DEVELOPMENT REVIEW BOARD  
SUPPLEMENTAL SUBMITTAL

PROJECT NO. PR-2019-002277  
Application No. SI-2019-00246

SUBMITTAL DESCRIPTION: DRB Site Plan Resubmittal.

RE: Adagio Apartments  
PR-2019-002277

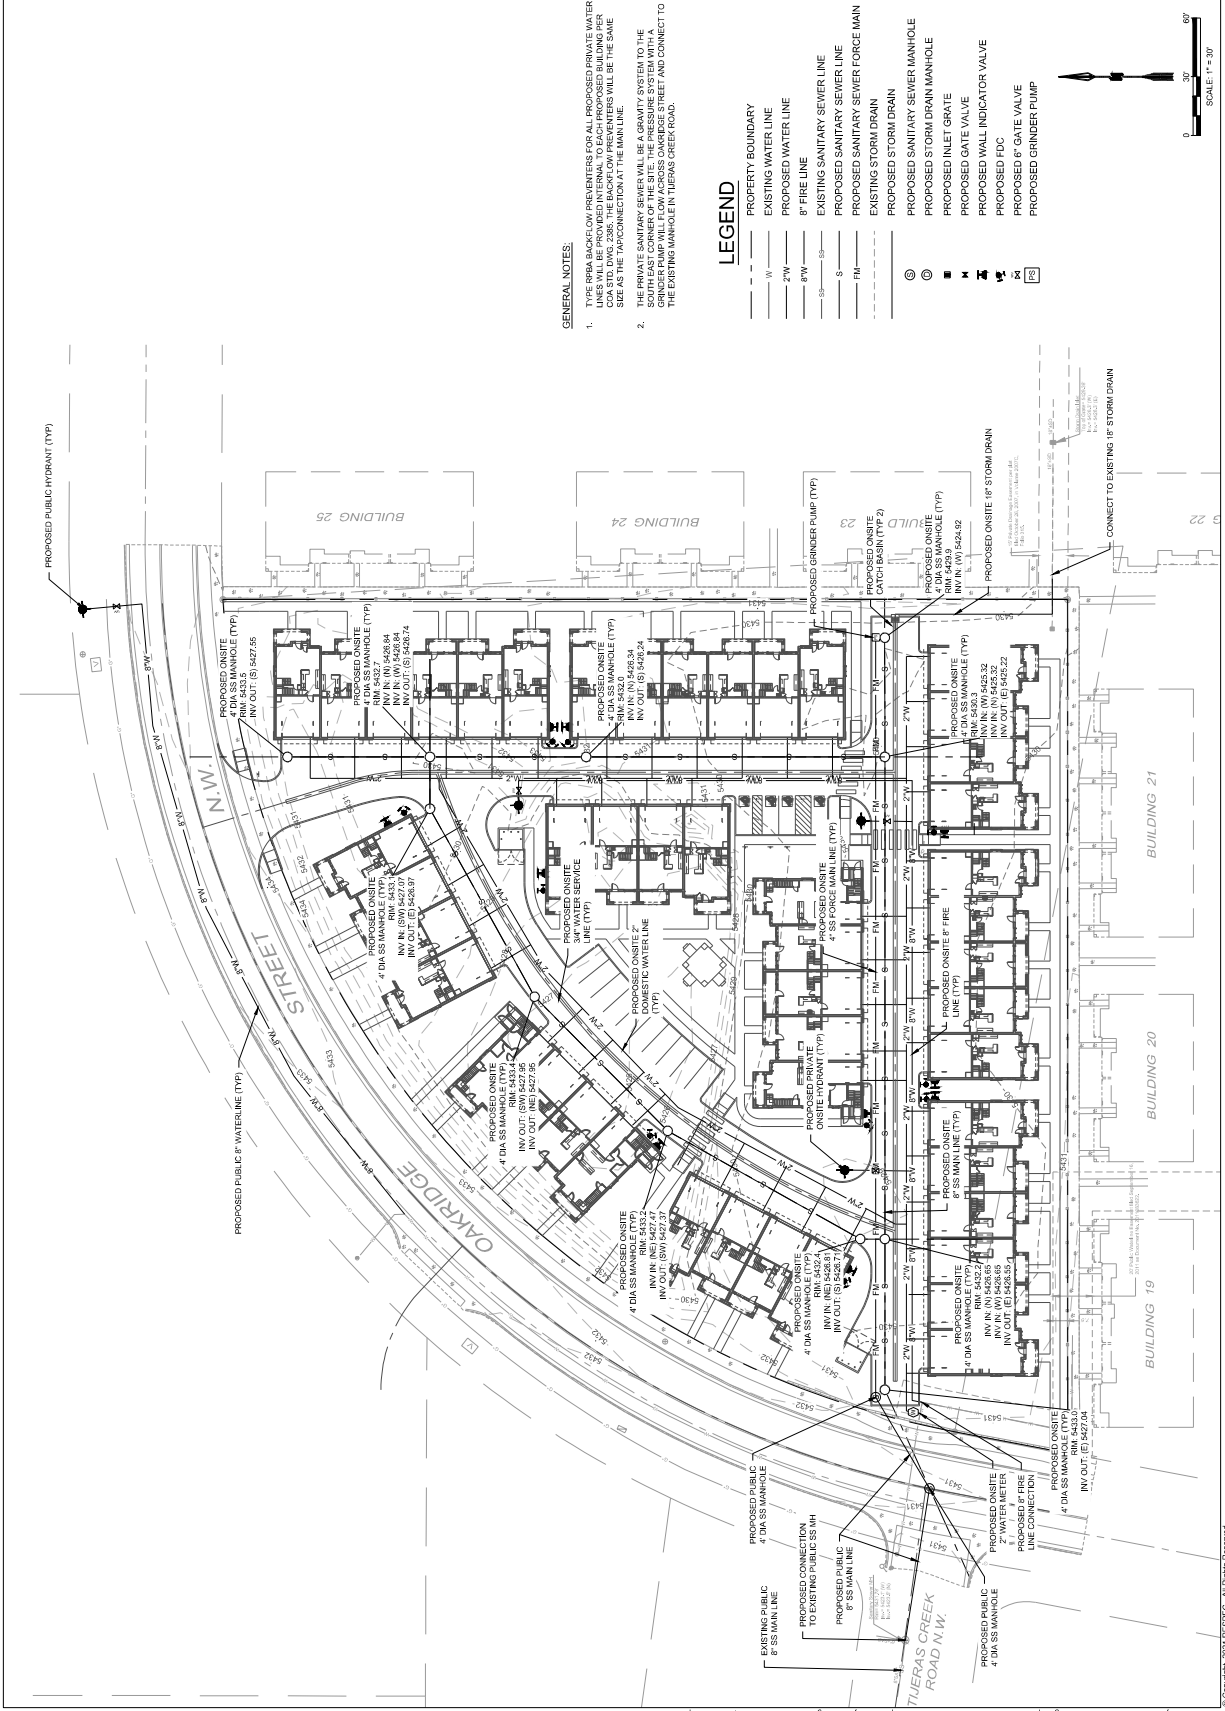
- / Utility Plan
  - If the 2-inch water meter does not provide sufficient flows, a larger meter, meter vault, and easement may be required. Please confirm sizing of the proposed meter.
    - *Response: Conceptual calculations have been completed and a 2-inch water meter will be sufficient to provide service to this development.*
  - Please label the 8-inch fire line connection.
    - *Response: The 8-inch fire line connection has been labeled. See revised Conceptual Utility Plan attached.*
  - Clearly delineate the existing versus proposed 8-inch sewer main.
    - *Response: Labeling for the existing and proposed sewer has been updated to clearly delineate between the two. See revised Conceptual Utility Plan attached.*

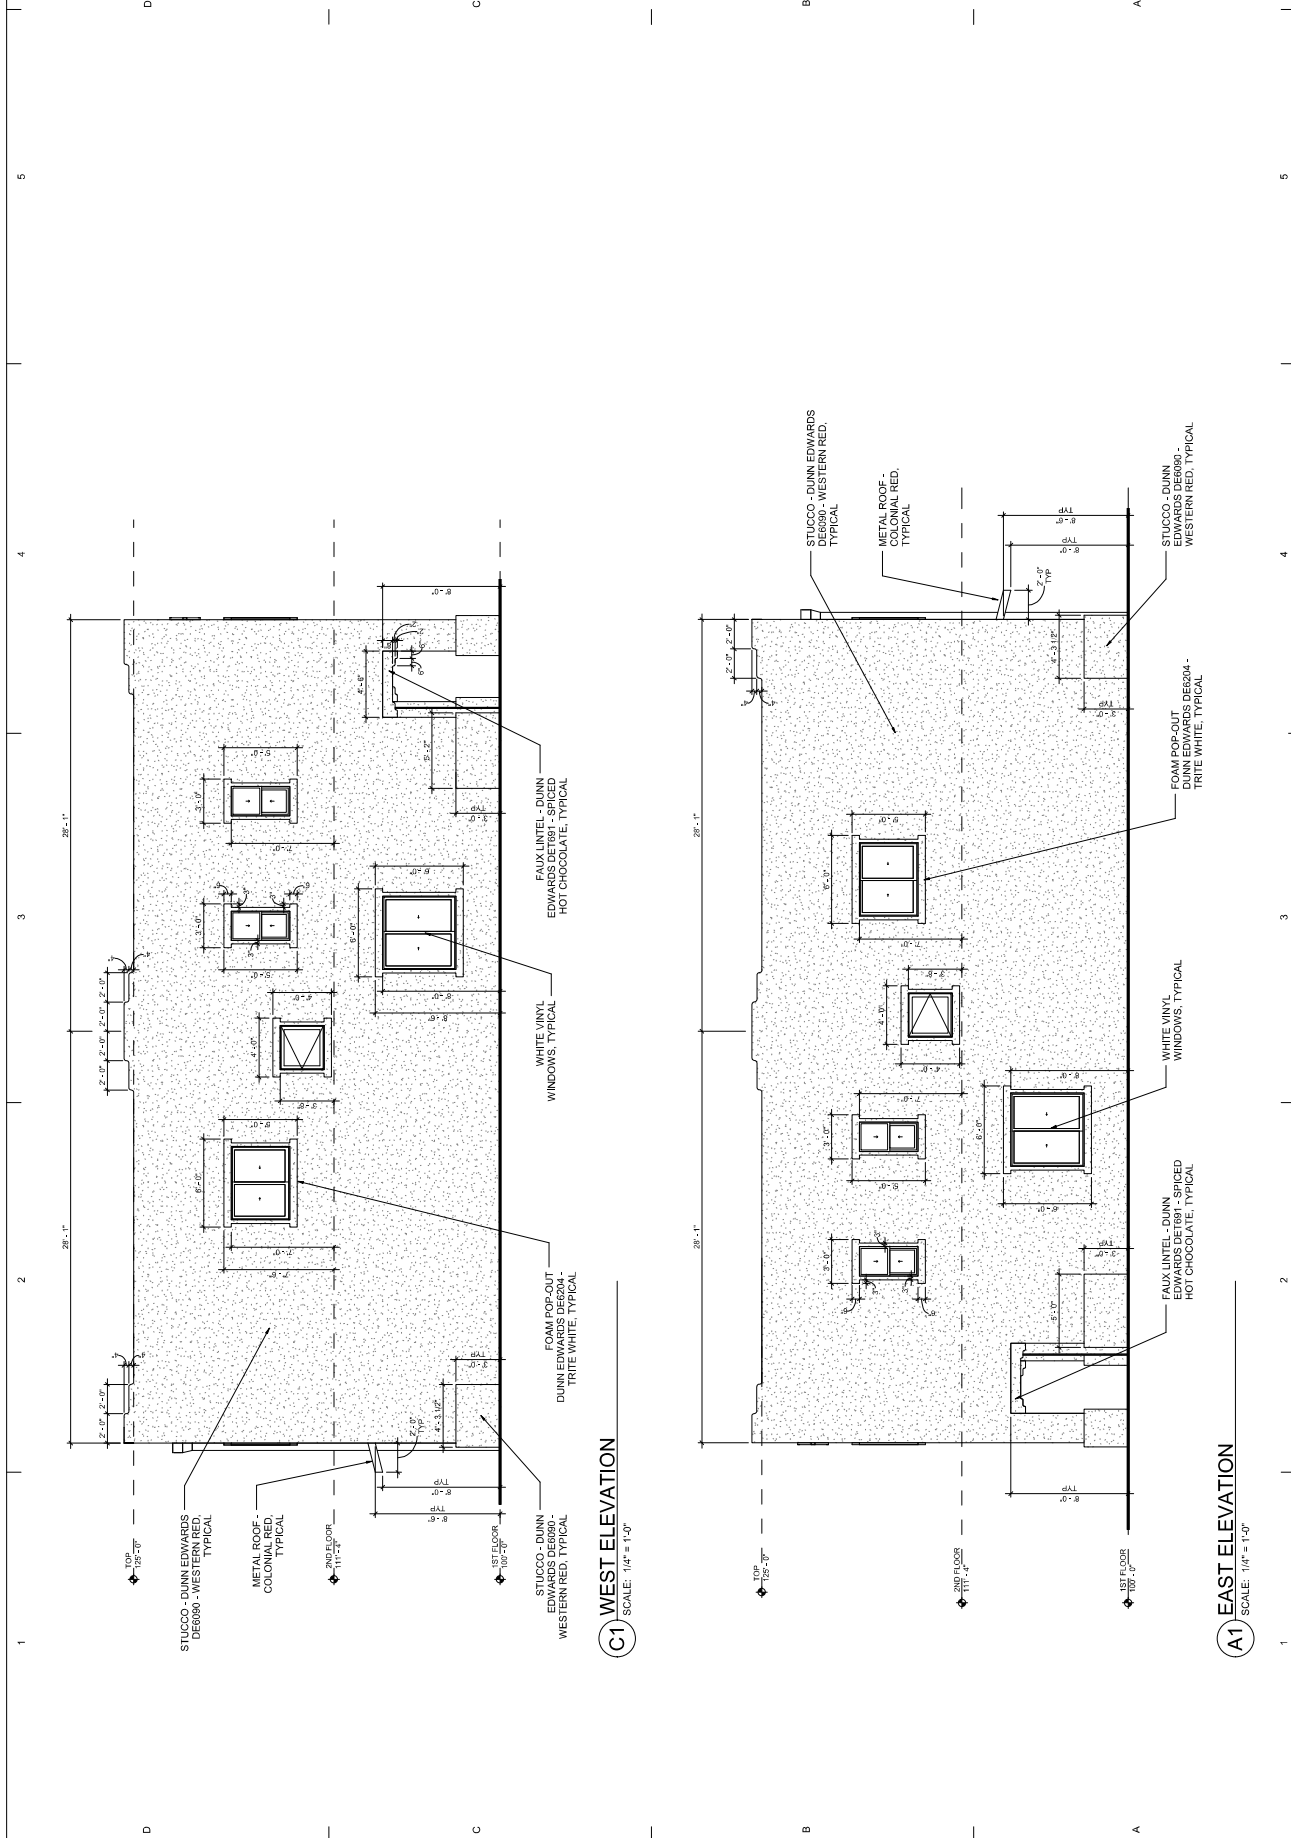
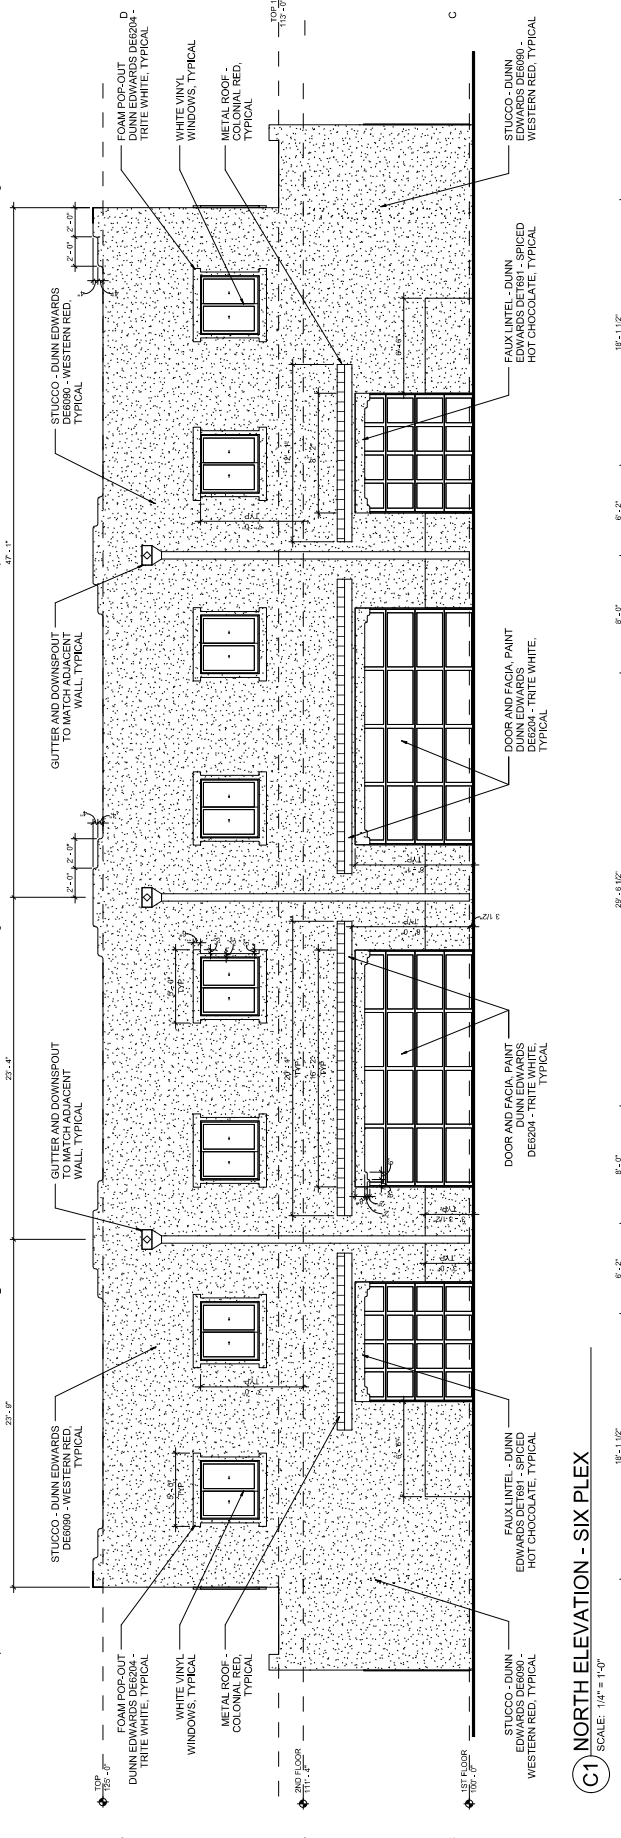
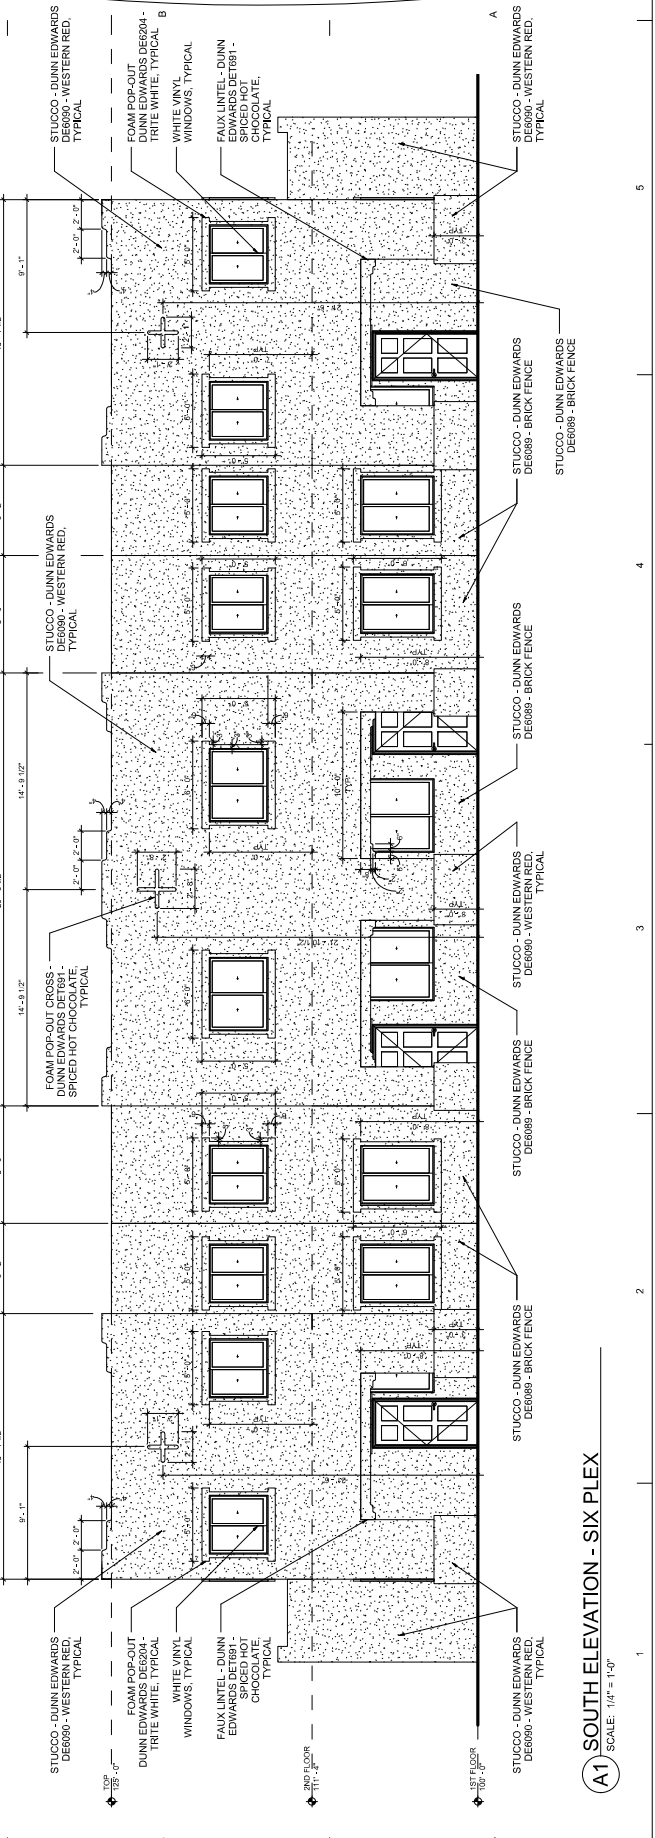
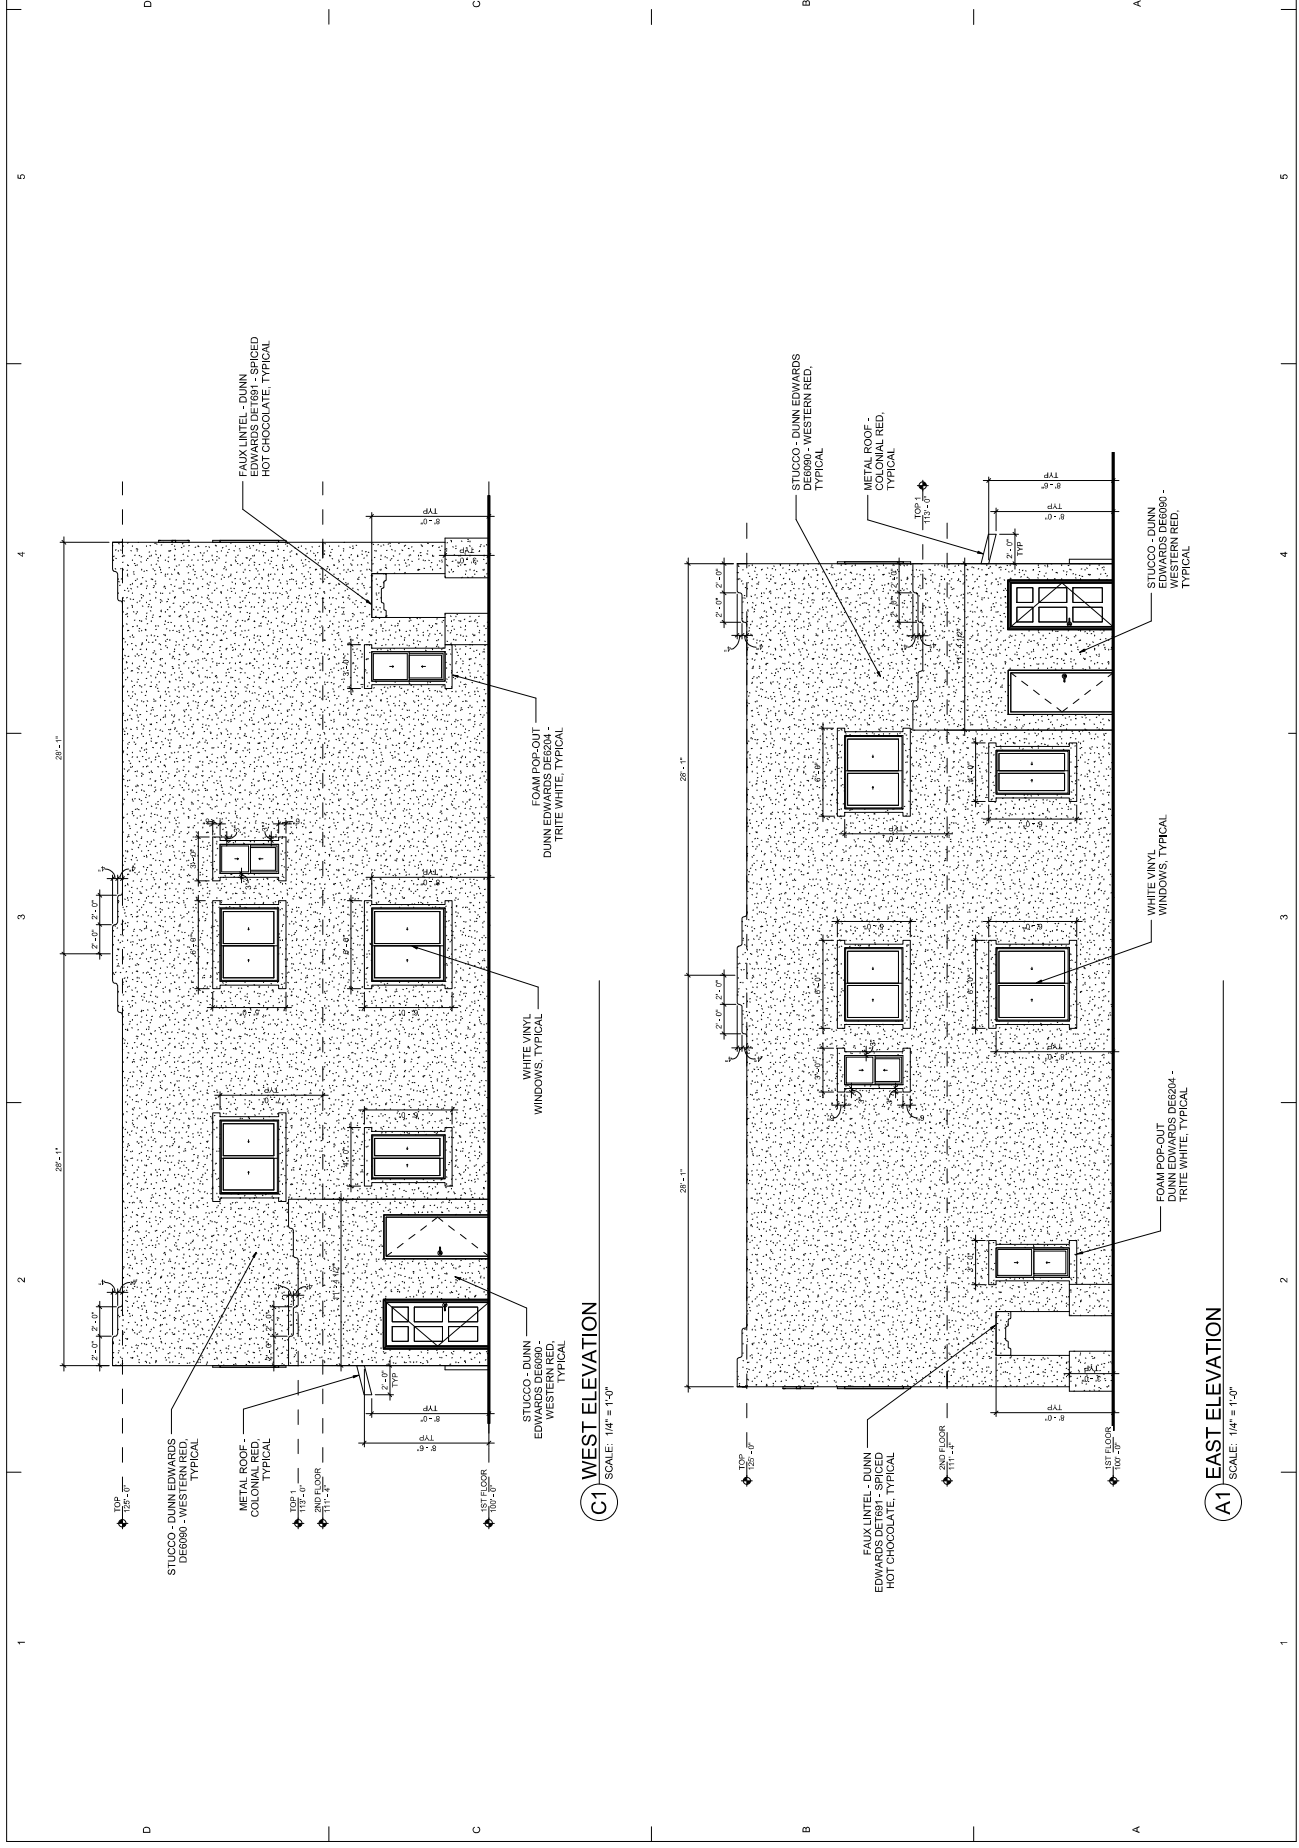
- / The townhomes shall have a color palette consistent with the depiction on the color elevations included in the October 20 supplemental submittal from the applicant.
  - o *Response: I believe this comment was addressed with our last submittal. Regardless, the latest elevations are included with this submittal.*
